RE: BREMERTON AUTO WRECKING LANDFILL GROUNDWATER MAP

The Kitsap County Health District (Health District) is writing to comment and clarify the groundwater situation you discussed in your letter to the Health District dated February 14, 2003, regarding the Bremerton Auto Wrecking Landfill (BAWL).

Bremerton Auto Wrecking Landfill

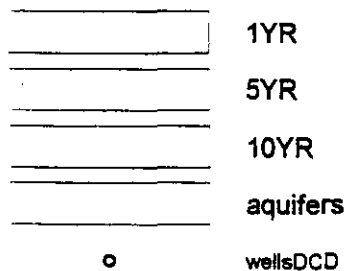
Attached is a map developed in our office with data from the local water PUD and Kitsap County's GIS office. The orange triangle shape in the lower center of the map is BAWL. The travel bars that run diagonally from bottom to top have at their head the City of Bremerton production wells for approximately 10,000 persons. Given the topography and the heavy drawn down from the City of Bremerton production wells it is reasonable to assume that groundwater flow is to the north, not northeast as stated in the SHA.
